Proposal for amendments to Regulation No. 13, Annex 12 Clarification/Simplification

The text reproduced below was prepared by the experts from France and Germany to simplify the verification of sufficient movement on the balancer without having to take measurements underneath the trailer in an potentially unsecured position.

Figure 5A
Mechanical-transmission braking system
 (See paragraph 2.3. of this annex)

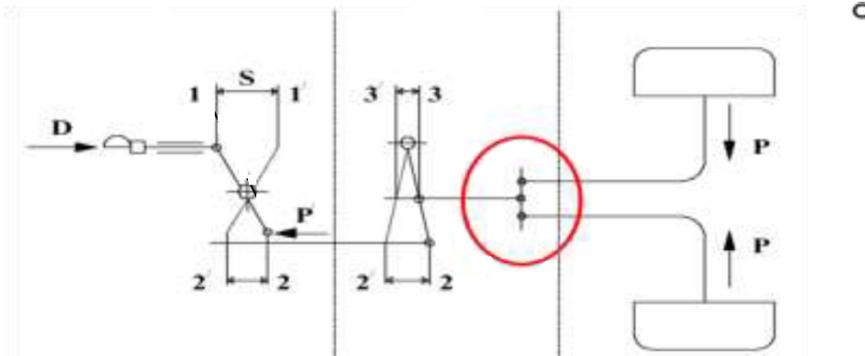
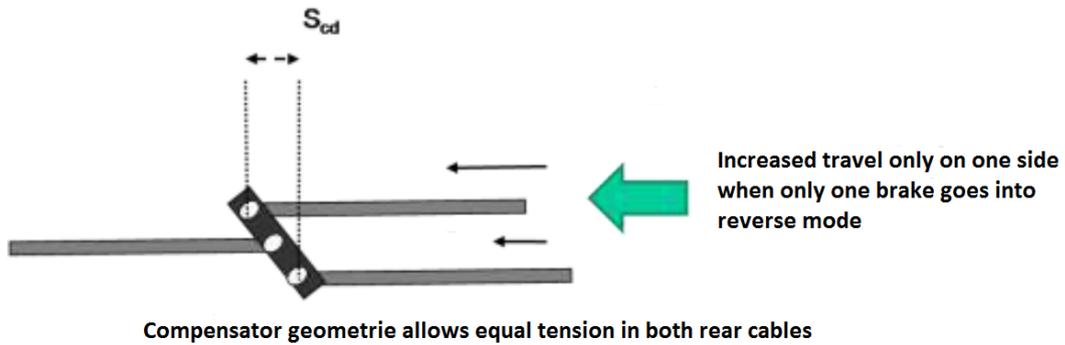
Annex 12 - Appendix 1 Figure 5A, amend to read:

Picture 2: inertia brake, scheme of travels at the wheel brakes (sR shall name sr)

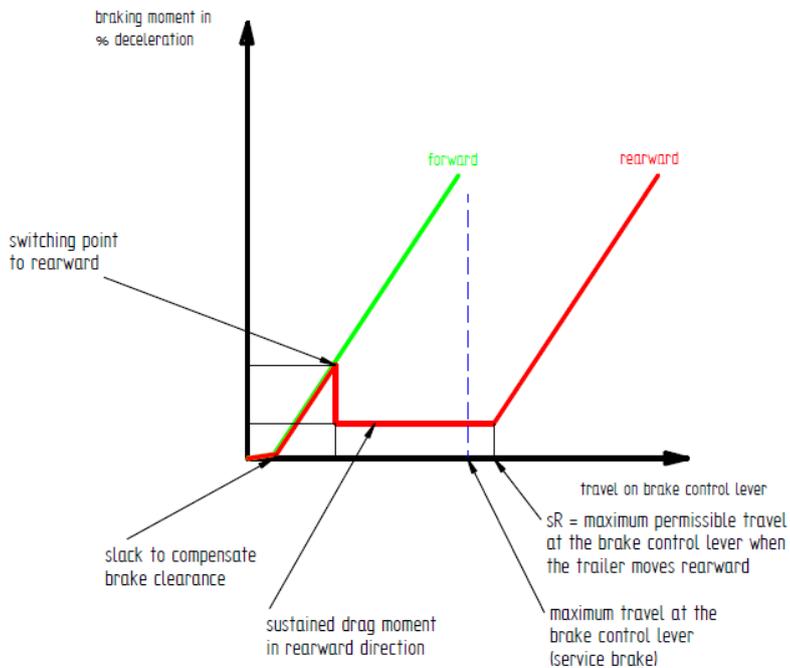
See Picture 1 at the right side of the s_r -point.

If both, the left and the right side wheel brake are in the same direction status either forwards or backwards the balancer has to compensate small strokes, only because of the wear or adjustment of the brakes.

Picture 3: unsuitable geometry of the balancer – in extreme, the whole actuating force (left rope) is transmitted into the lower rope / left hand side brake. The right hand brake is unbraked because of long travel

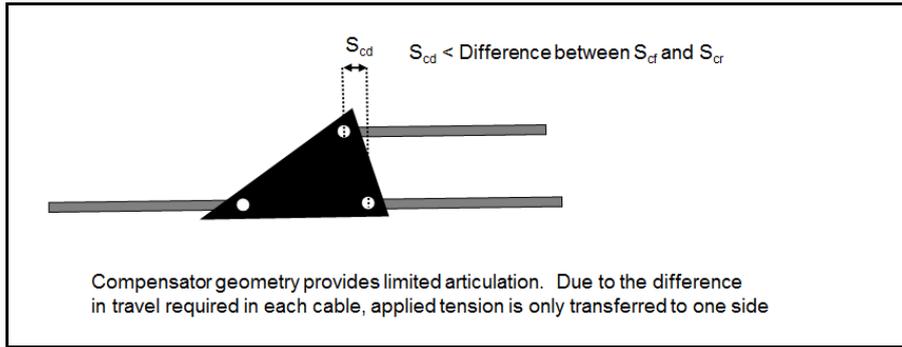
Due to unsuitable geometry of the balancer (a triangle, see picture 3) the transmission rate between left hand and right hand side was changed and only the forwards brake was actuated. The trailer turned around the braked wheel and killed a man under the trailer standing in the open sewer.
